Architect's Supplemental Instructions

PROJECT: *(name and address)*
Wilma P. Mankiller Health Center
Expansion
Stilwell, OK

ASI INFORMATION:
ASI Number: Bid Package 01 - ASI 004

Bid Package 01- ASI 04 – Wilma P. Mankiller Health Center Expansion

DATE:	11/01/19	JOB NUMBER:	18-01.01
SHEET NUMBER:	S1.01		
FOUNDATION PLAN SECTOR 1

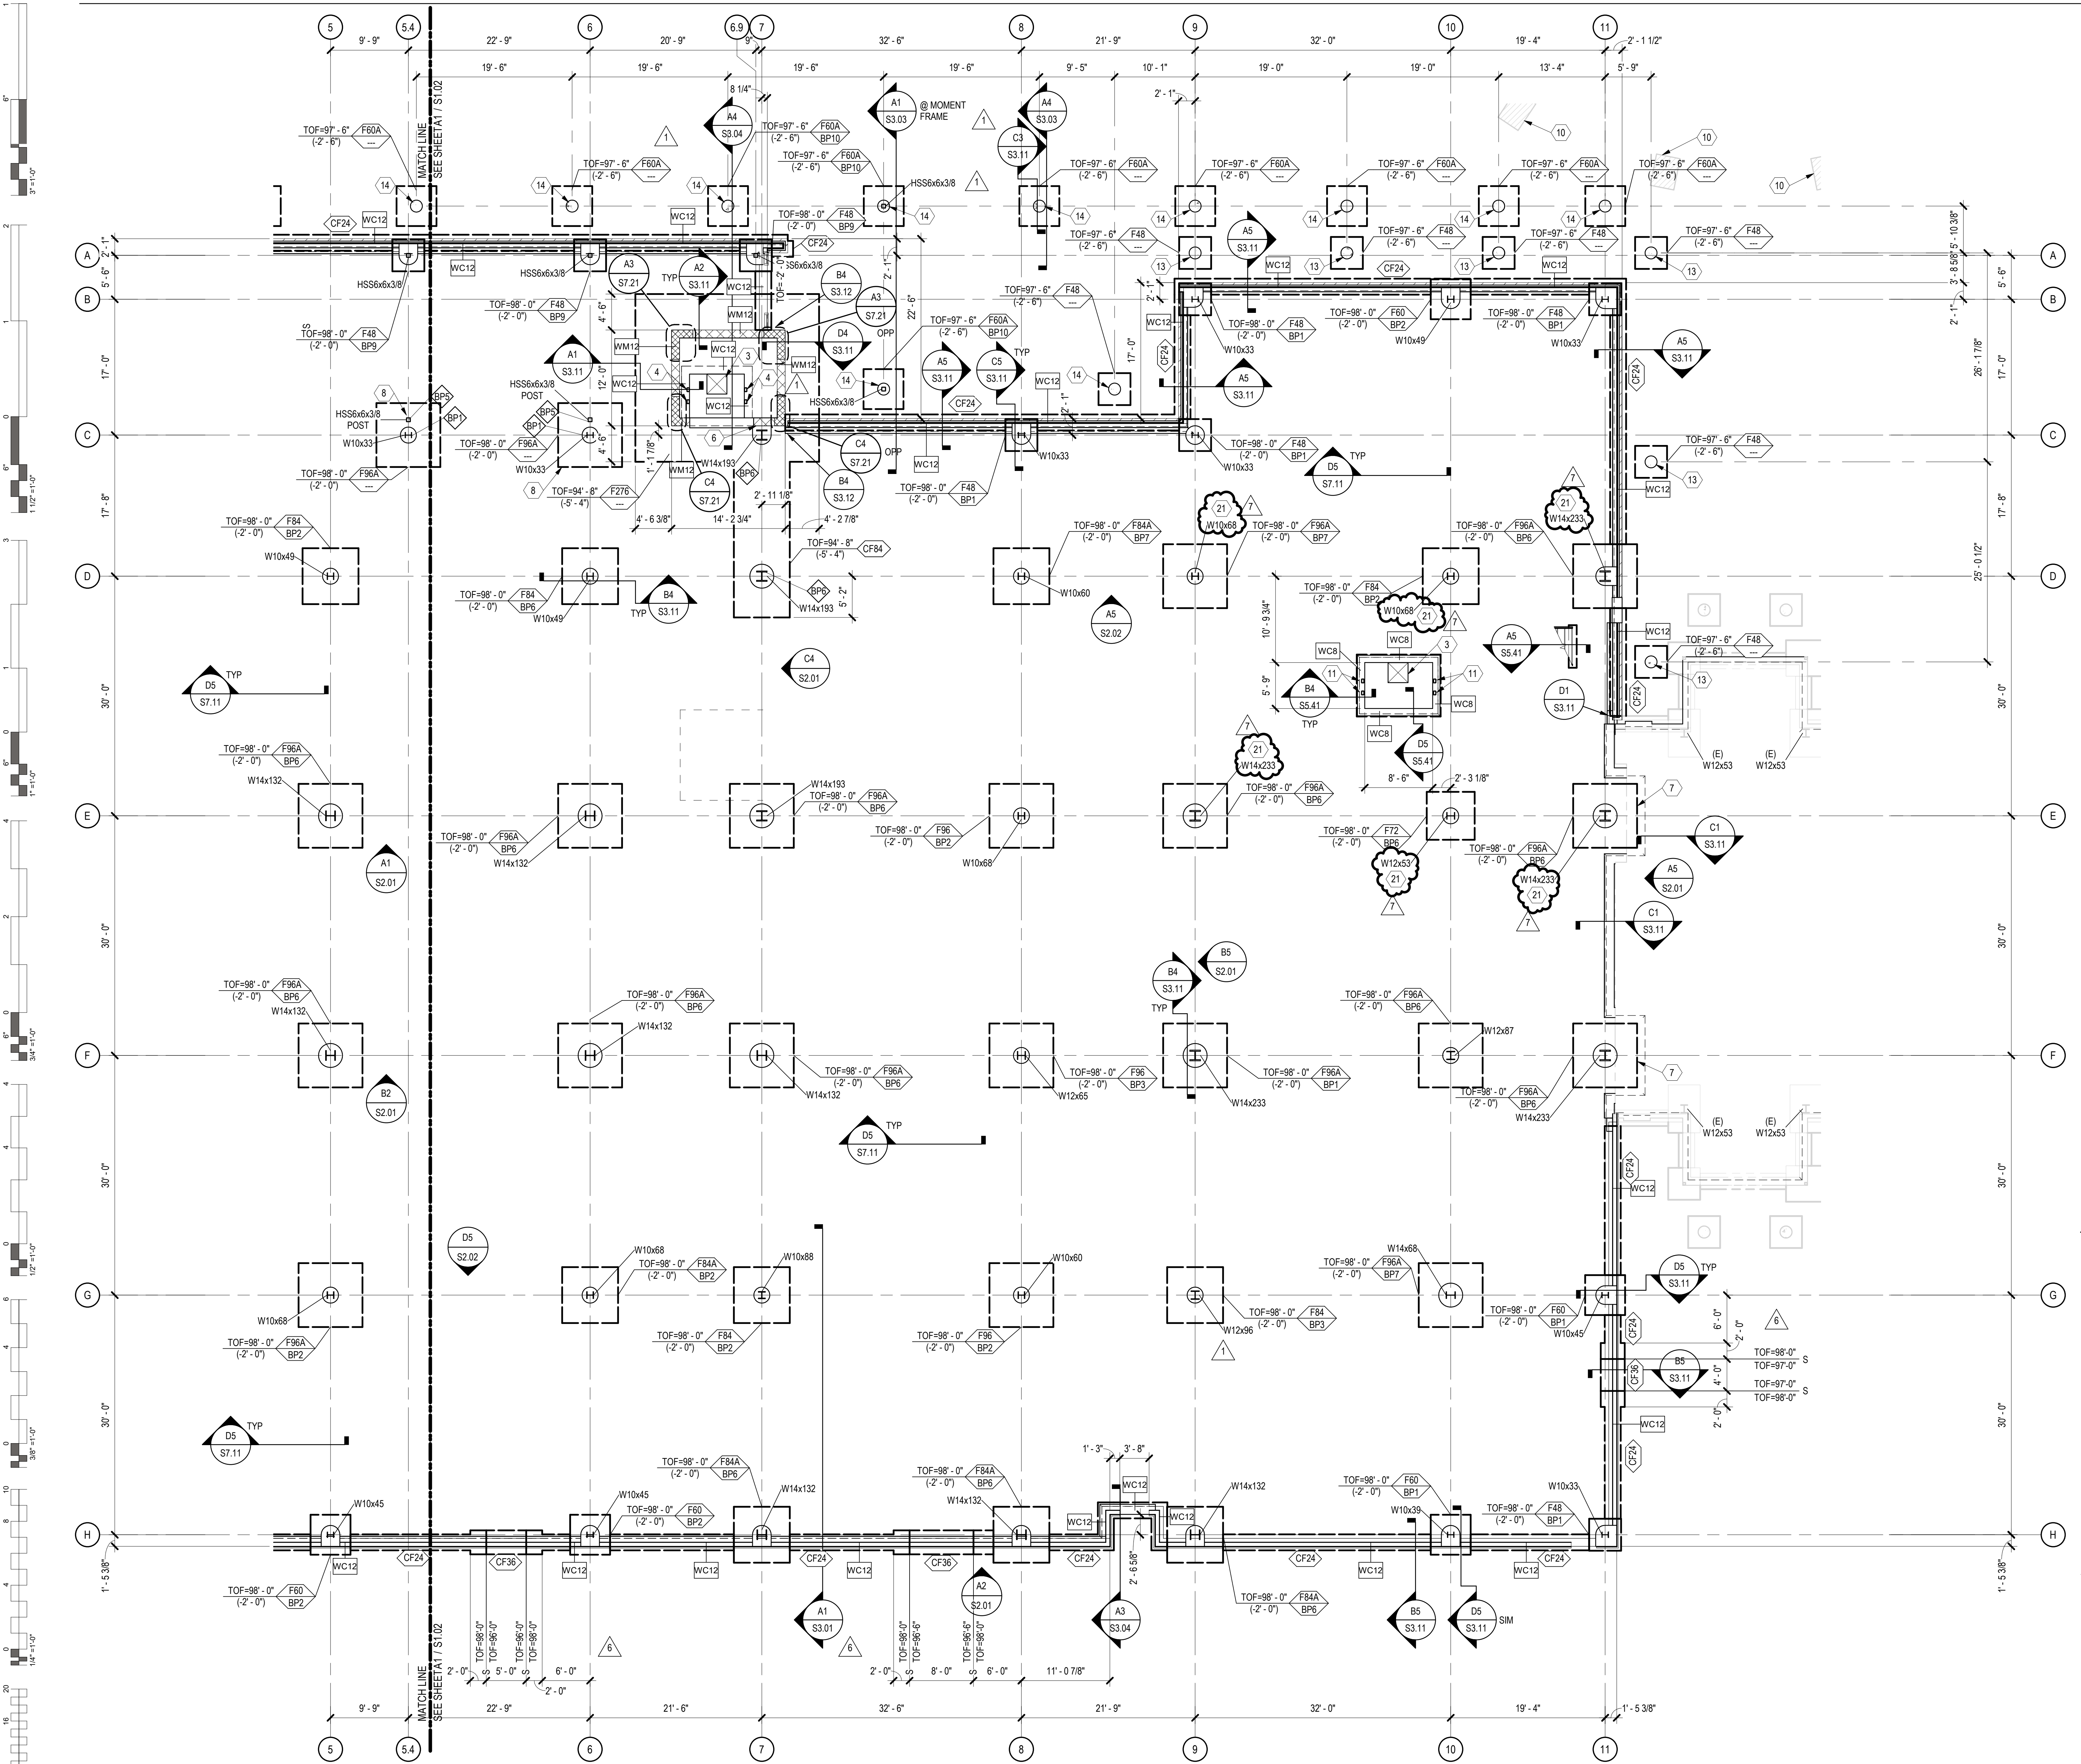
<u>Sheet</u>	<u>Description</u>
S1.01	Keynote 21, with associated plan annotations, added.
S1.02	Keynote 21, with associated plan annotations, added.
S1.11	Keynote 13, with associated plan annotations, added.
S1.12	Keynote 13, with associated plan annotations, added.
S1.13	Keynote 13, with associated plan annotations, added.
S1.21	Keynote 9, with associated plan annotations, added.
S1.22	Keynote 9, with associated plan annotations, added.

19. SEE C3 / S3.12 FOR SUPPORT OF CONTINUOUS FOOTING.
20. SITE RETAINING WALL. SEE B2 / S3.12. SEE CIVIL DRAWINGS FOR EXTENT.
21. STRUCTURAL MEMBER, INCLUDING ASSOCIATED DECK EDGE SUPPORT PER S7.21, SUPPORTING EXIT STAIRS AND/OR RATED ENCLOSURE. SEE LIFE SAFETY DRAWINGS FOR FIREPROOFING REQUIREMENTS.
